RE: Request for Septic Setback Waivers
14314 Roxbury Meadow Drive
Glenwood, MD 21738

Owner:	David Powell 14314 Roxbury Meadow Drive Glenwood, MD 21738		
Title:	Revised Percolation Certification Plan for 14314 Roxbury Meadow Drive		
Subdivision:	Clarks Meadow Lot 18		
Drawing Prepared By:	RHINE LAWN CARE & LANDSCAPING, LLC 13805 Old Frederick Road, Glenwood, MD 410-442-2445 www.rhinelandscaping.com		
Tax Map:	21	Plat Ref:	18482-18484
Parcel:	227	Election Dist.:	3rd
		Date:	10/4/12
		Sheet:	1 of 1

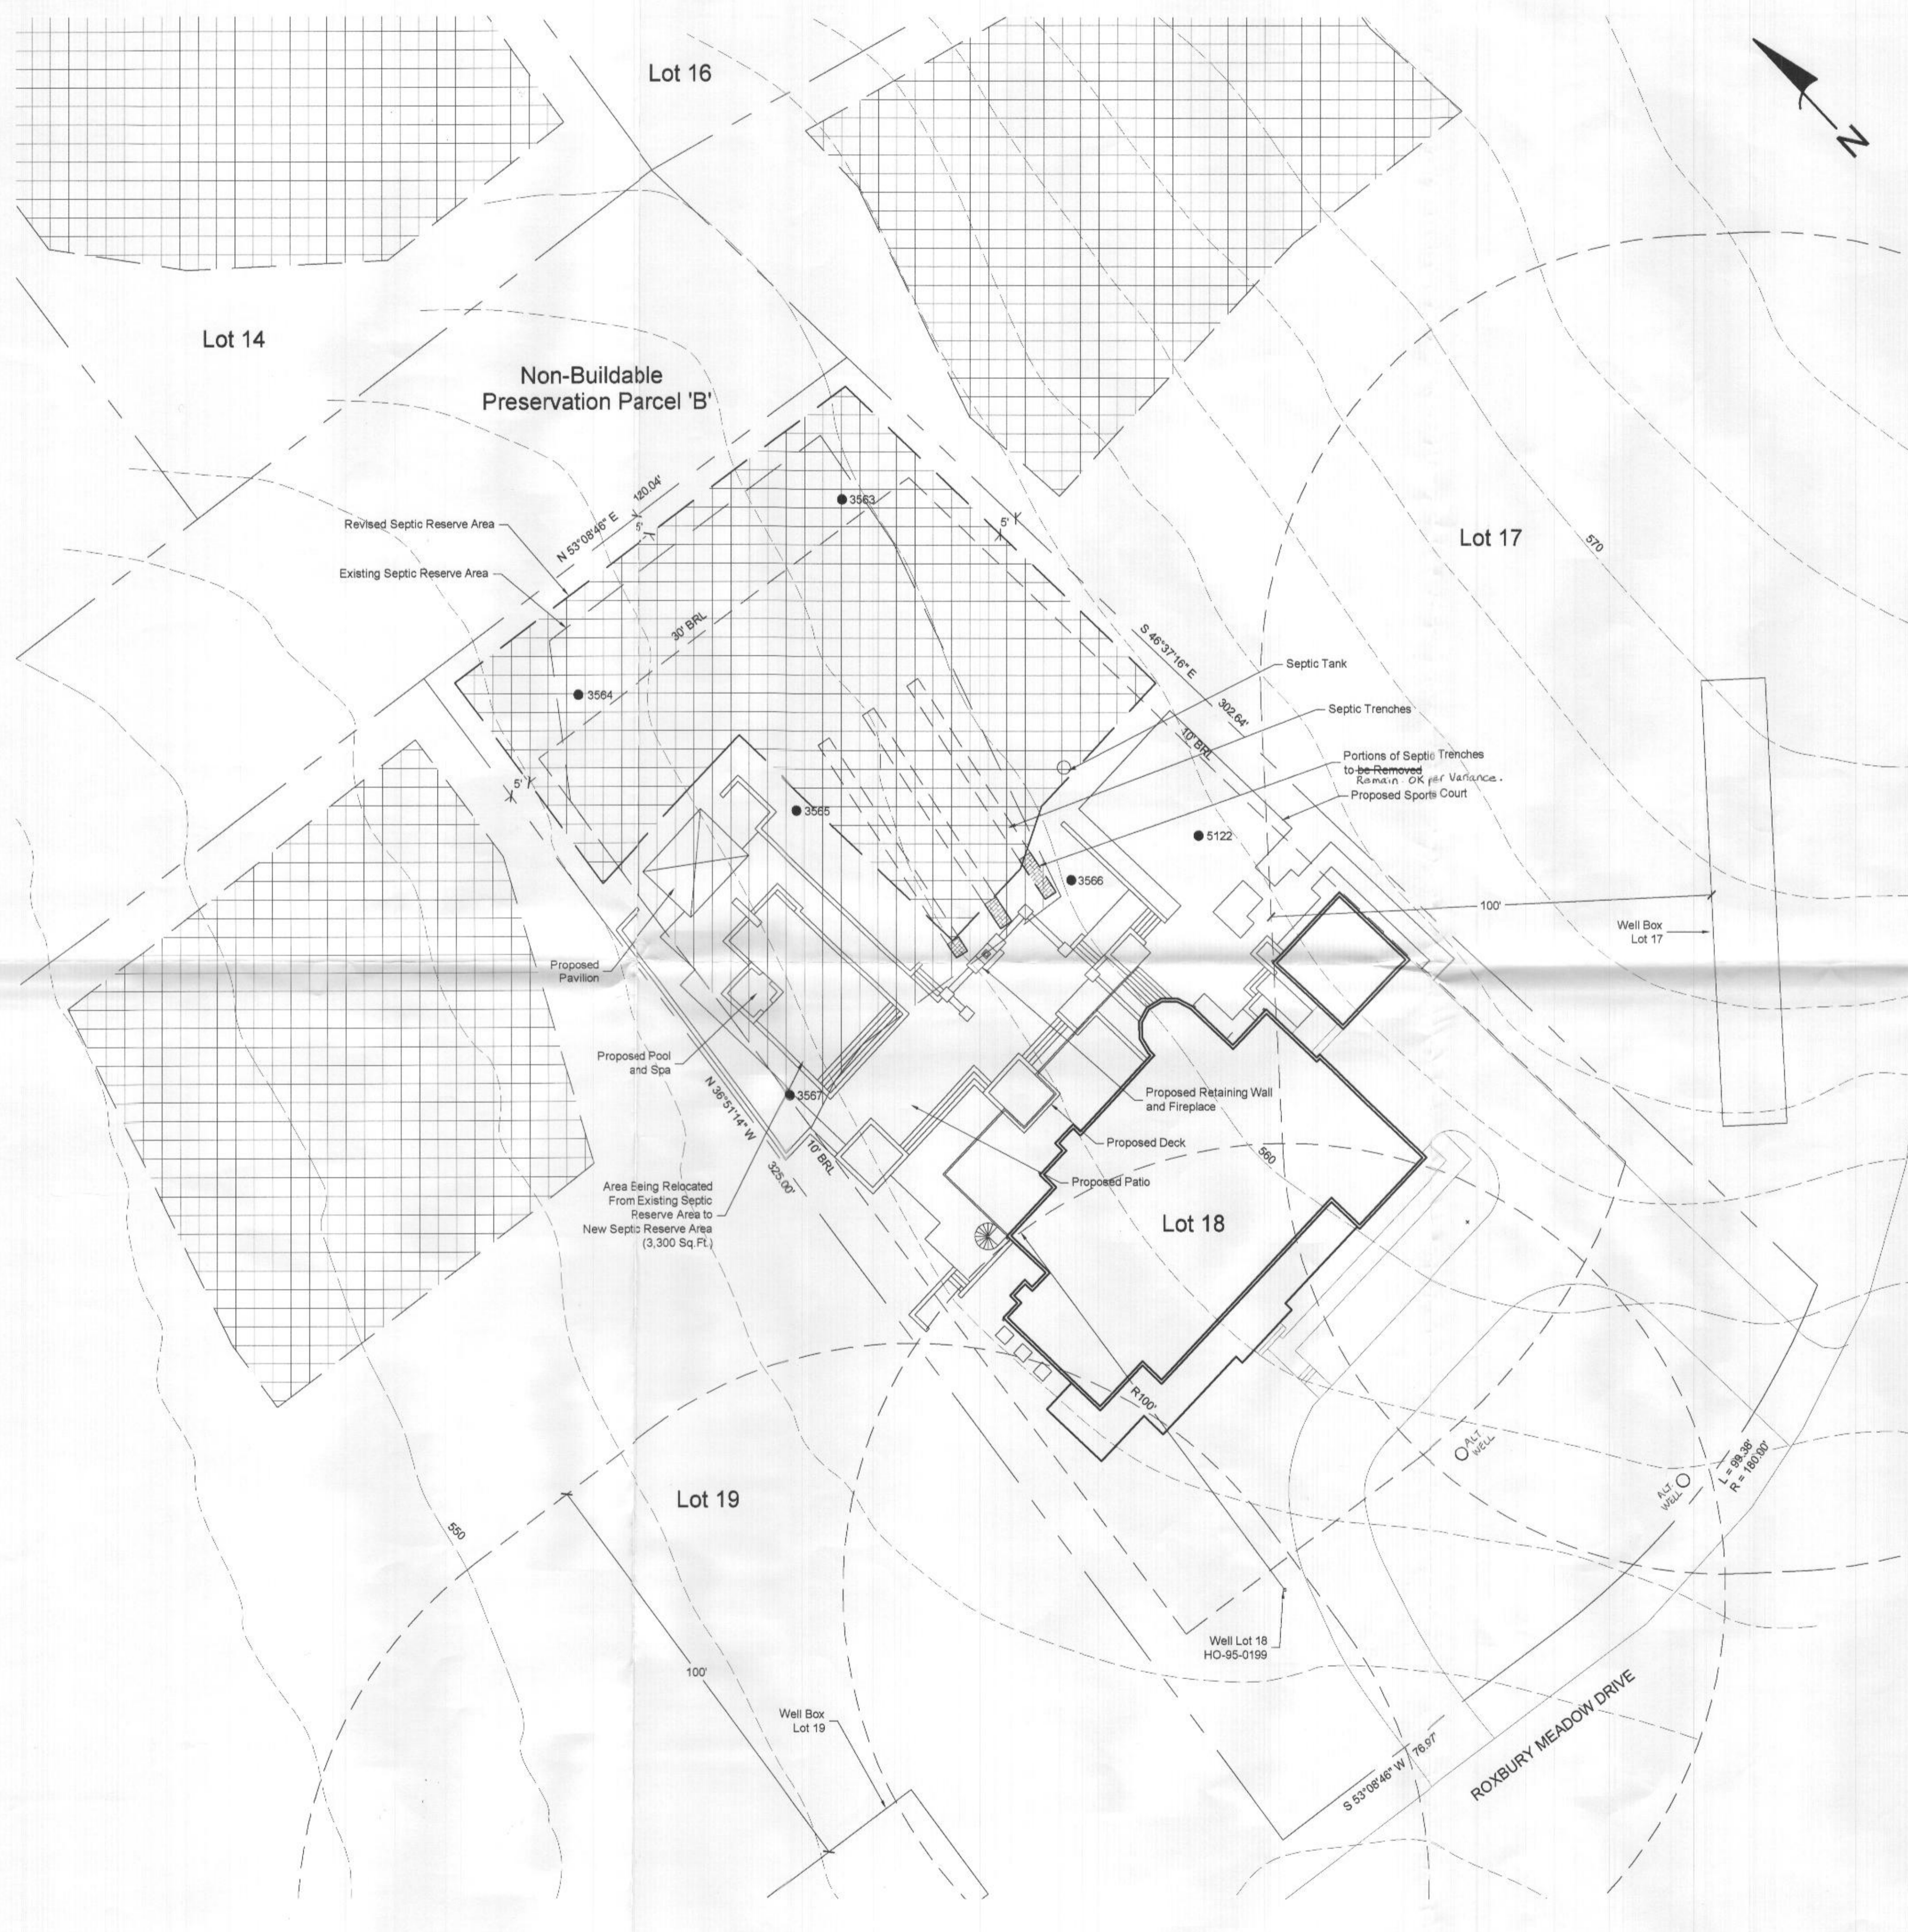
We are writing this letter to request your authorization for waivers to reduce the normal ten (10) feet setback from the septic reserve easement to the property line to five (5) feet so that a new swimming pool and patio installed on the property and reduce the minimum setback from the septic tank to a sports court from ten (10) feet to five (5) feet. Three (3) copies of the revision to the Percolation Certification Plan on record (6/3/2003) are enclosed for your review and approval. Approximately 3,300 square feet of reserve easement would be relocated on-site with this alignment. We have reviewed the plan for the locations of wells on the adjacent properties and did not identify any potential conflicts. Furthermore, we looked at the perc tests and septic reserve easements on the adjacent parcels and noticed that the adjacent septic easements are located in the same general vicinity as the locations where we would like to expand. Also, there were no apparent problems with the existing perc test data.

As part of the development for the back yard, we are also seeking to remove a combined total of approximately twenty (20) feet from the septic trenches. We would be removing ten (10) feet from the first trench, six (6) feet from the second trench, and four (4) feet from the third trench. During a meeting on Monday, October 1, 2012, Robert Bricker, reviewed the septic calculations and determined that the existing system was 'over-designed' and could accept the deduction in trench length without adverse effects.

10/26/12
Approved
mg Davis
waived to
keep ex
trenches
approved
